STORM SEWER IMPROVEMENTS to serve LOTS 23, 25, 27, 29, 31, 33, 35, 37 & 39 RICHMAND'S ADDITION

1031 S. MERIDIAN AVE CITY OF WICHITA, KANSAS

AS BUILTS

1	TITLE SHEET
2	STORM SEWER PLAN AND PROFILE
3	EROSION CONTROL PLAN
4	STORM SEWER DETAILS
5-9	EROSION CONTROL BMP DETAILS
10	PLAT

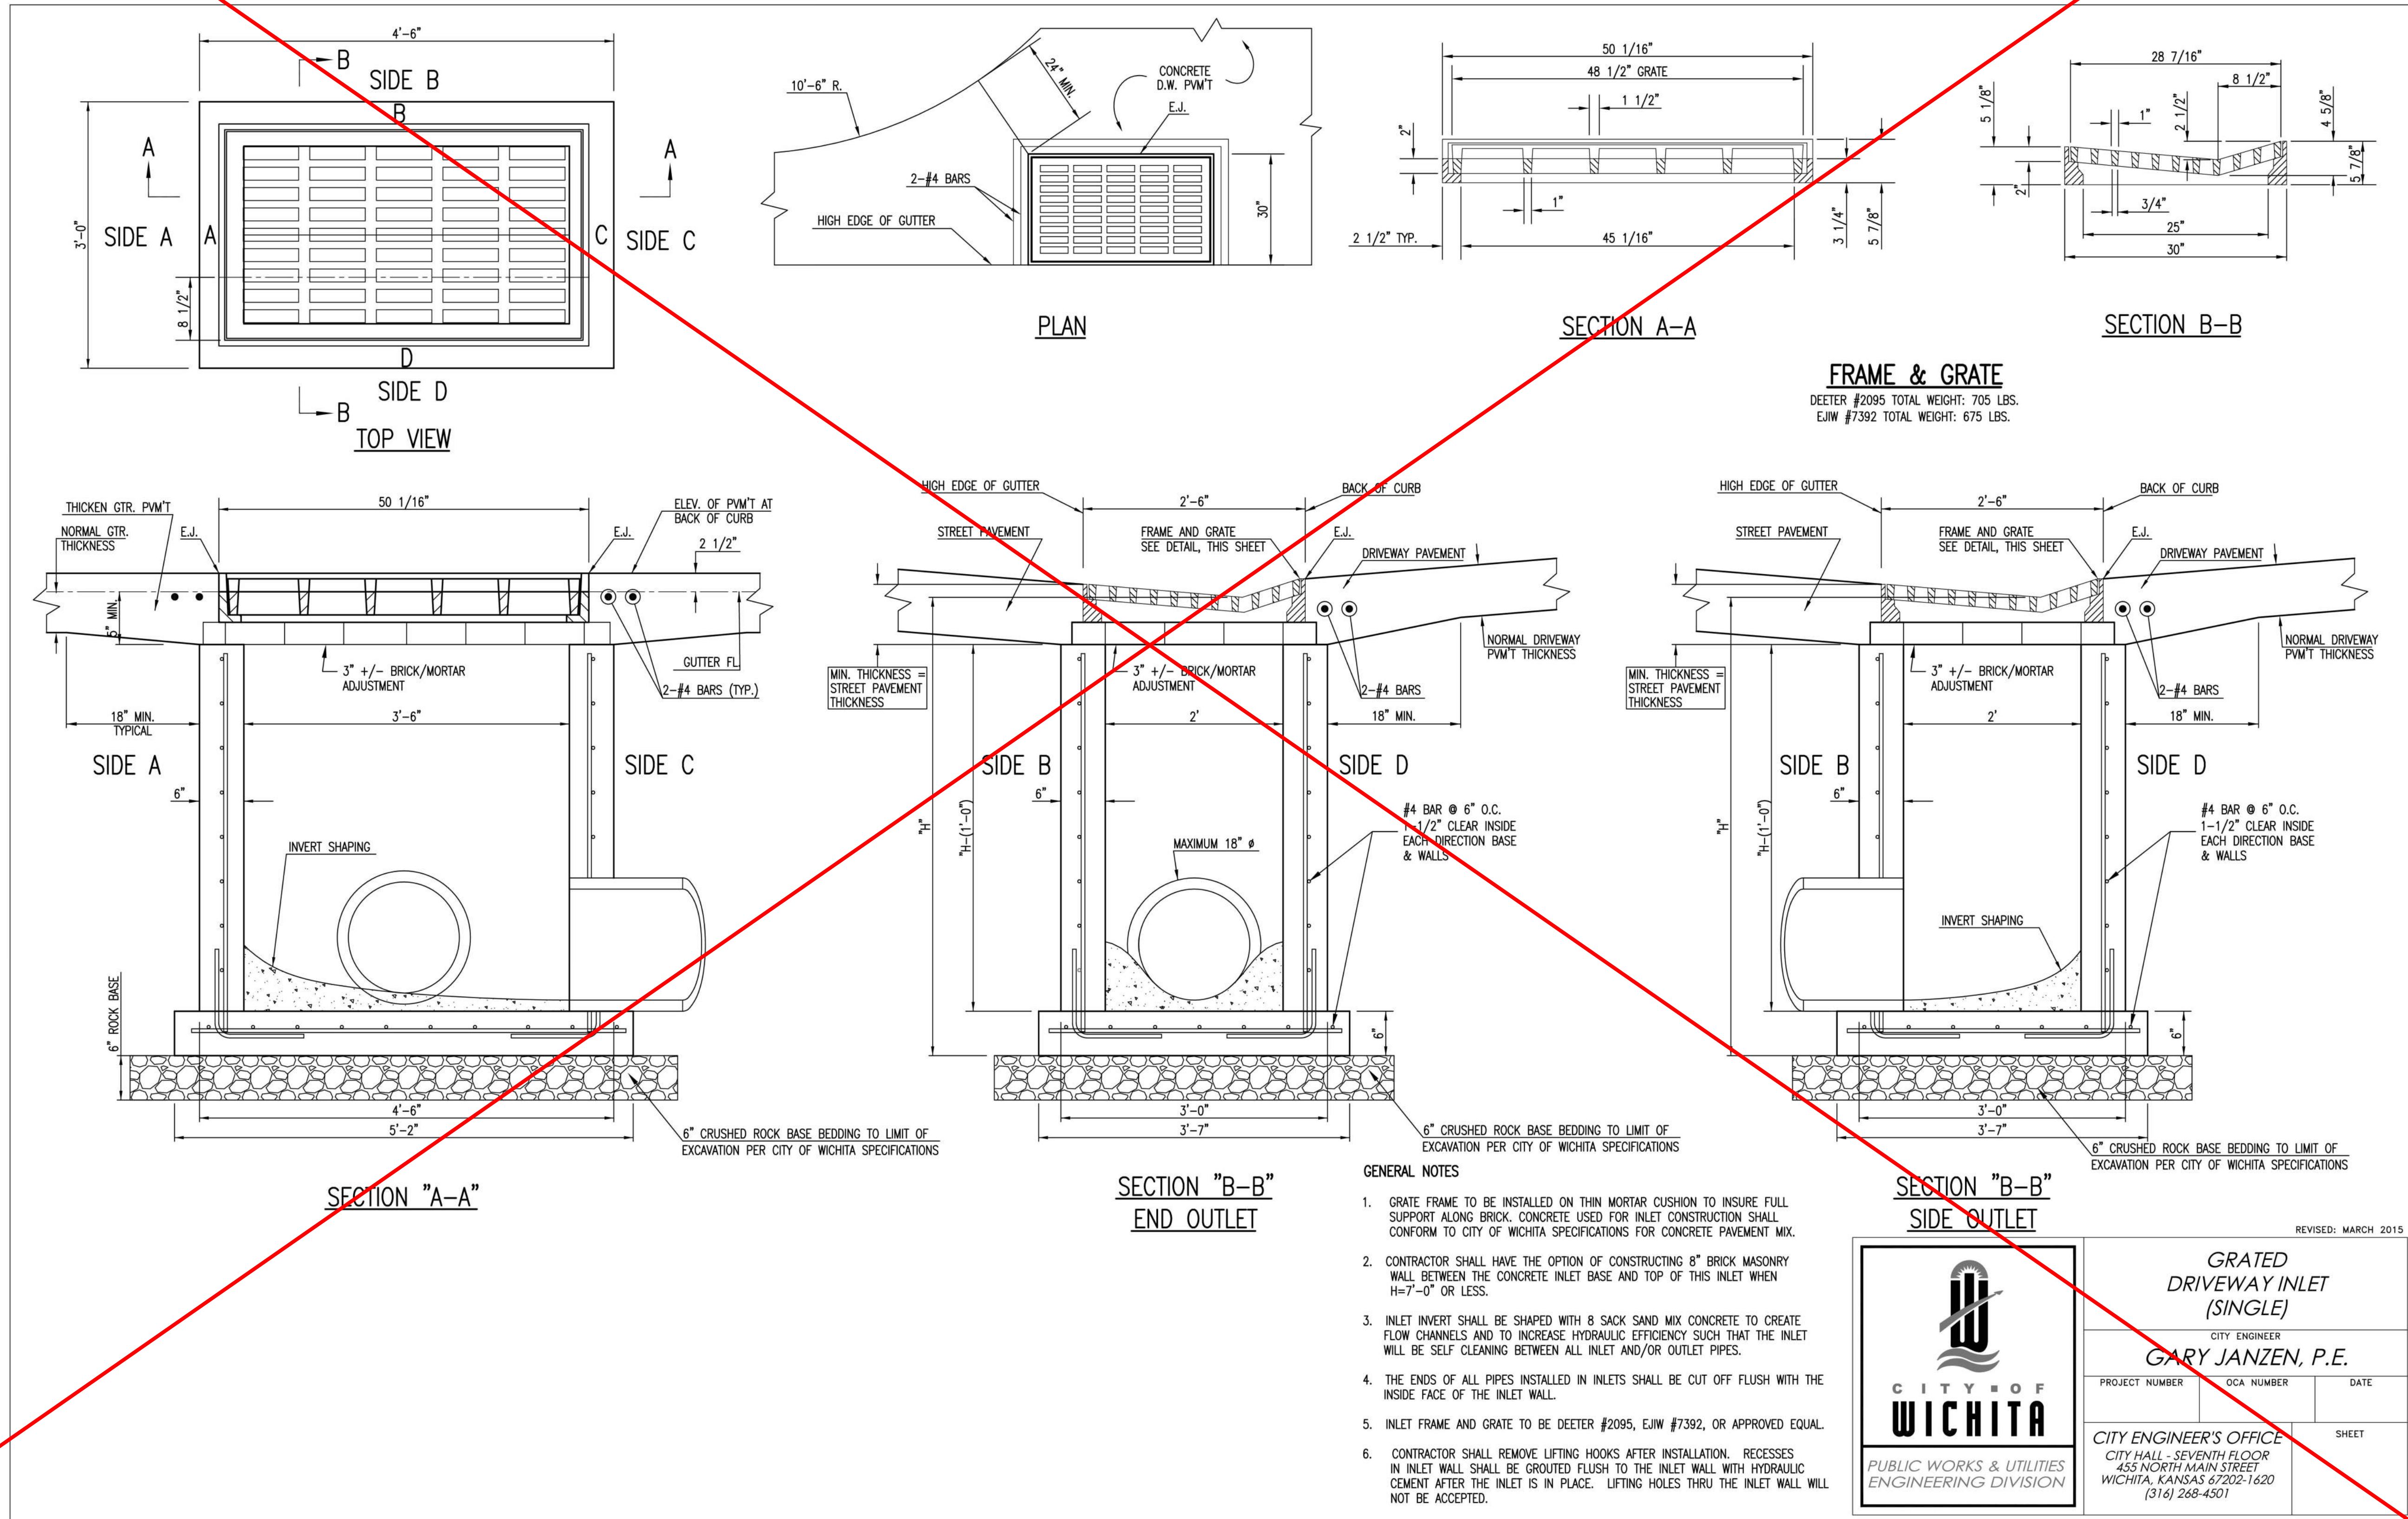
NOTE:
Existing water line clearance issue
2'X2 inlet replaced with 4' round manhole with 2' ring and grate.
